MFN 08-016

**Licensing Topical Report NEDO-33083-A,
Supplement 1, Revision 1,
"TRACG Application for ESBWR Stability Analysis,"
January 2008**

**TRACG Application for ESBWR
Stability Analysis**

SUBJECT: REISSUANCE OF SAFETY EVALUATION REGARDING THE APPLICATION OF THE GE-HITACHI NUCLEAR ENERGY AMERICAS LLC (GEH) LICENSING TOPICAL REPORT "TRACG APPLICATION FOR ESBWR STABILITY ANALYSIS," NEDE-33083P, SUPPLEMENT 1

Figure 8

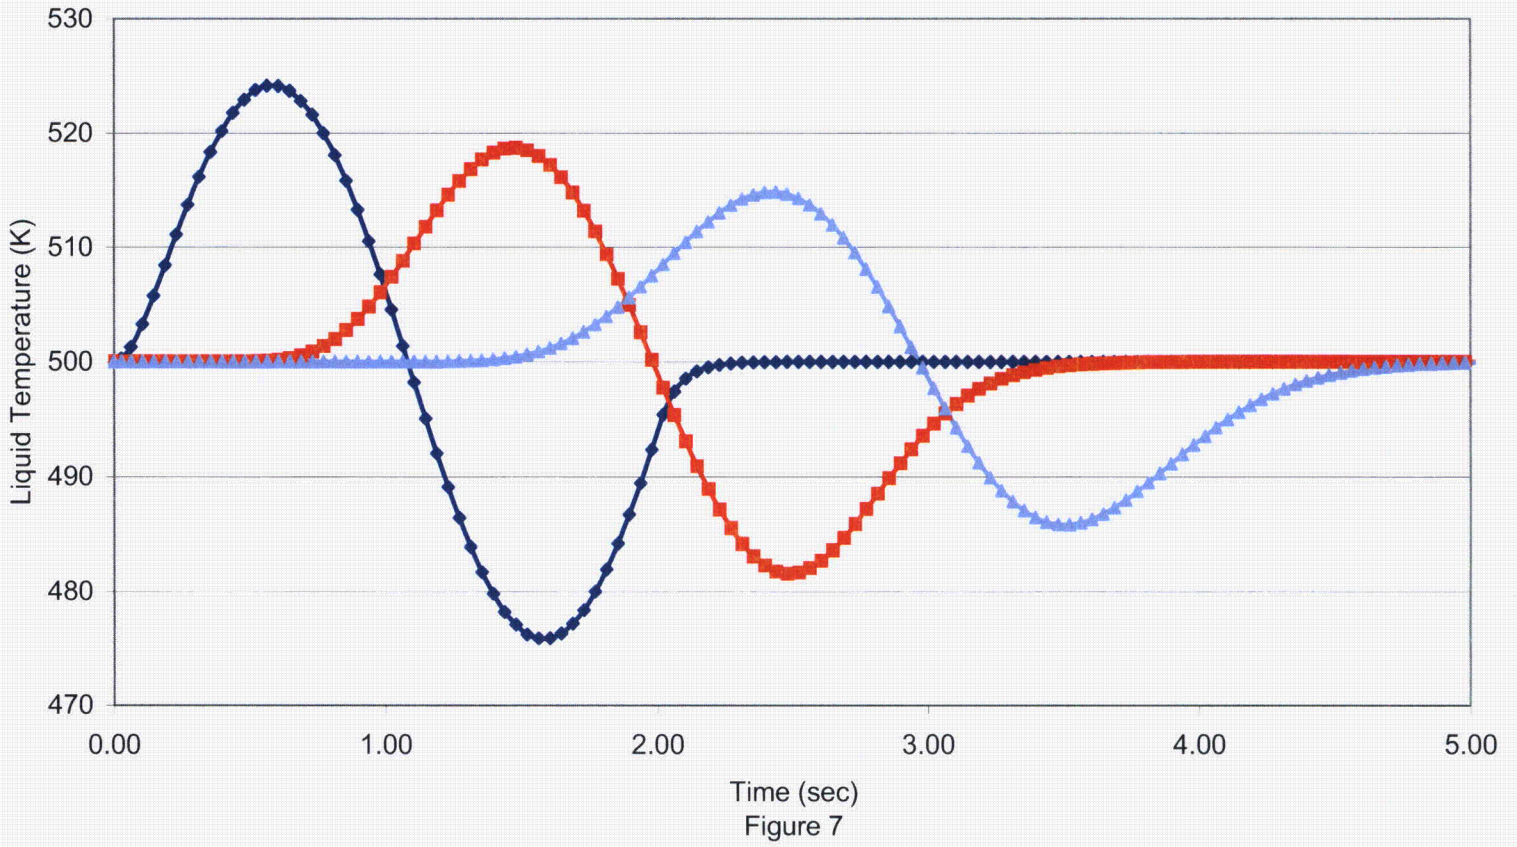
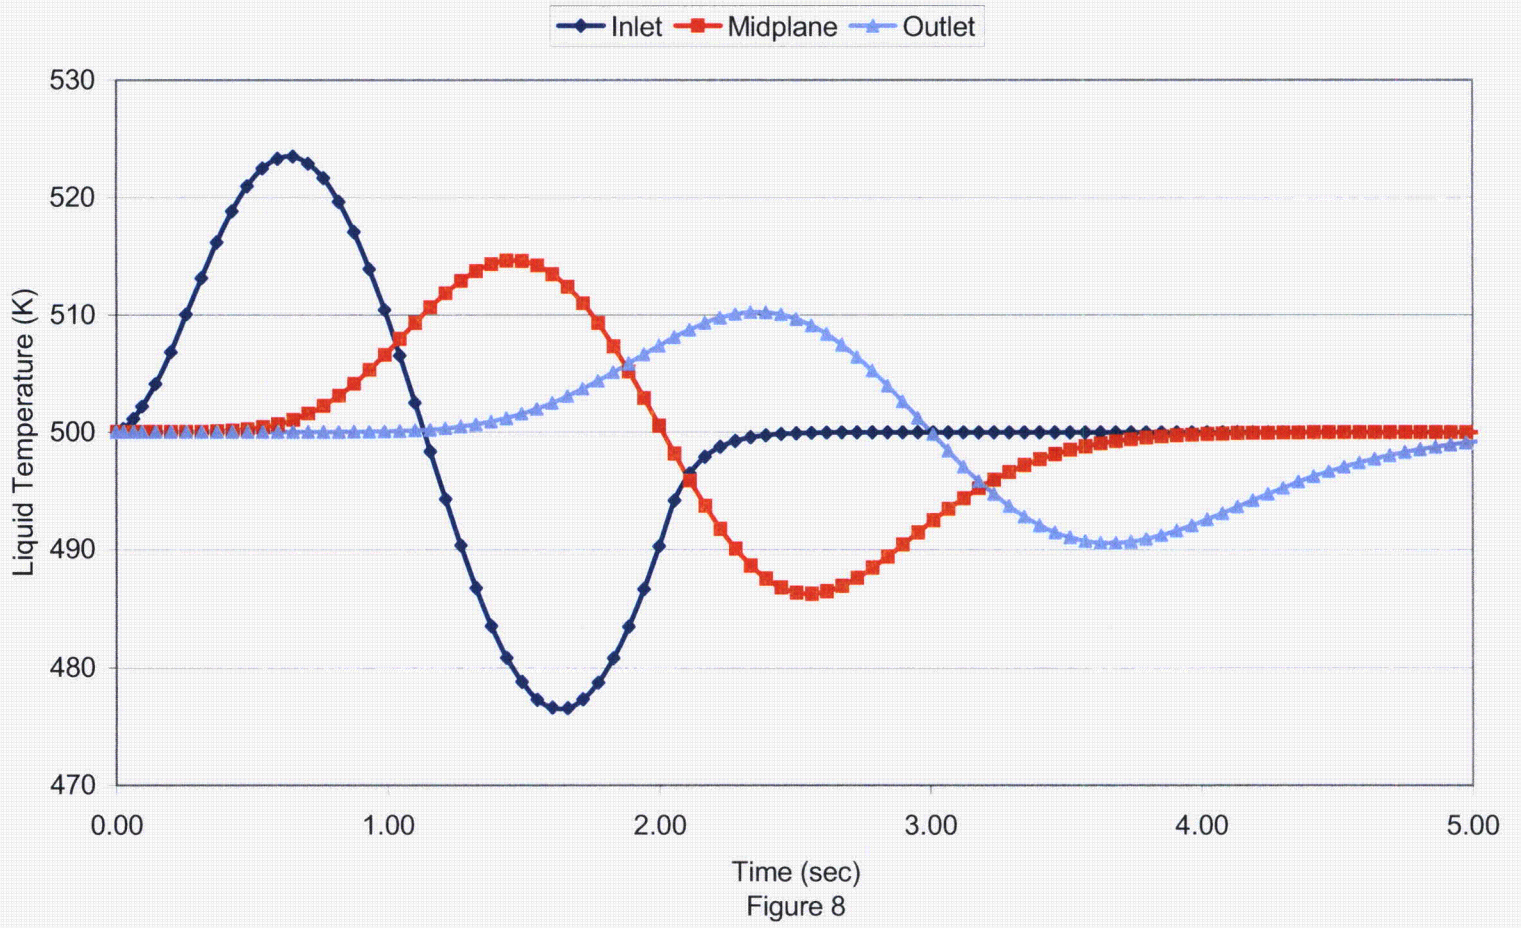
figures. Figure 8 of this SE shows the difference when the implicit method is used. There is noticeable dissipation as compared to Figure 6, which has the same Courant multiplier. This demonstrates that use of the explicit method option and GE's process for nodalizing the core and setting the Courant multiplier to 1.0 are appropriate for minimizing numerical dissipation in a time domain code.

Figure 1. ESBWR Hot Channel Void Fraction Profile Predictions.

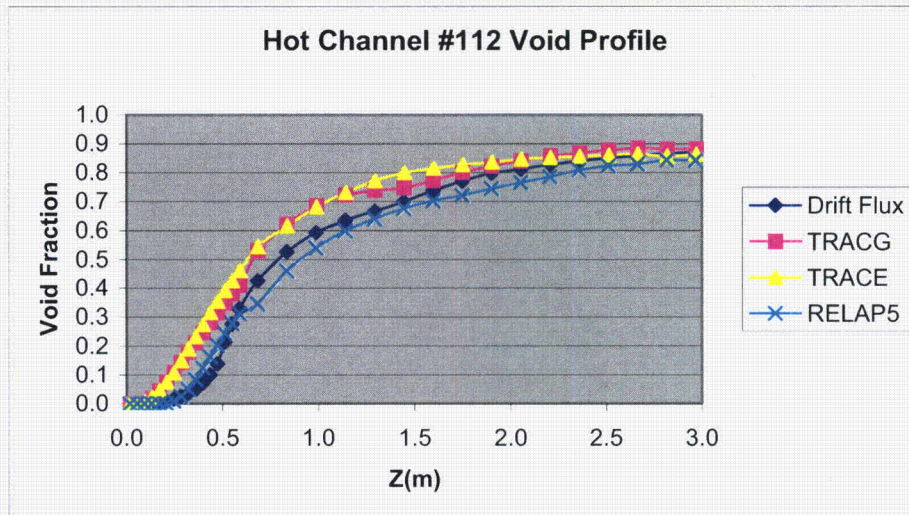
A standalone drift flux program for a single ESBWR channel was developed to estimate the steady-state void fraction and velocity profiles. The standalone drift flux program includes TRACG documented models (Reference 11) for the drift flux parameters and subcooled boiling. Based on this model the estimated density wave transport time for the ESBWR hot bundle is [[]] seconds, which implies an instability frequency of

[[]] Hz. This is slightly below the lower range of expected frequencies for the ESBWR. One explanation for the difference in transport times is the difference in void fraction profiles between TRACG and the standalone drift flux program. Comparison of the void fraction profile predicted by the drift flux standalone program to TRACG, TRACE (Reference 12), and RELAP5 (Reference 13) for the ESBWR hot channel is given in Figure 1.

RAI 14 [MFN 05-136]

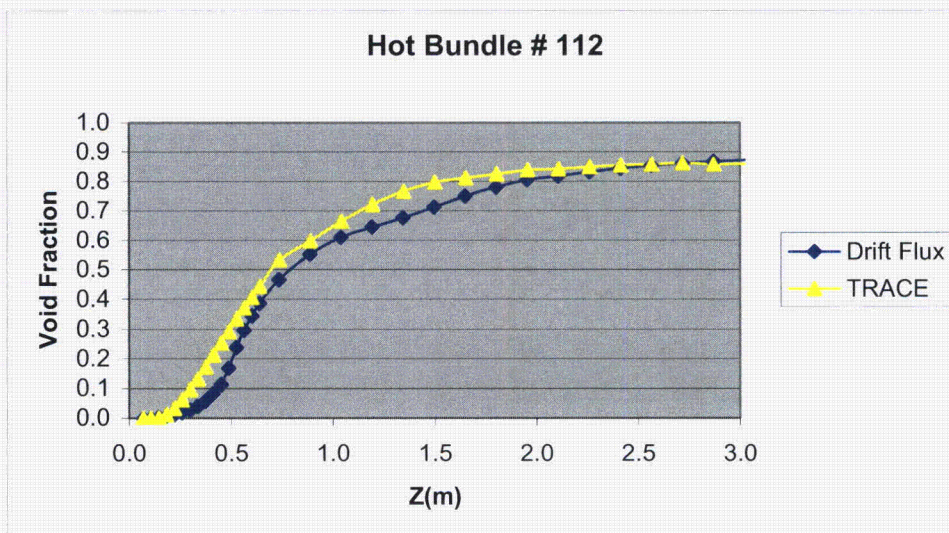
BOC is bounding exposure for channel decay ratio. MOC is bounding exposure for core decay ratio. What about a clean core (i.e. zero exposure) rather than an equilibrium cycle? Have any calculations been completed for completely fresh core (i.e. zero exposure)?

An initial core design has not been developed for the ESBWR. For purposes of demonstrating the application methodology, an equilibrium core was judged to be sufficient. The actual initial core will be analyzed using the approved methodology at COL.
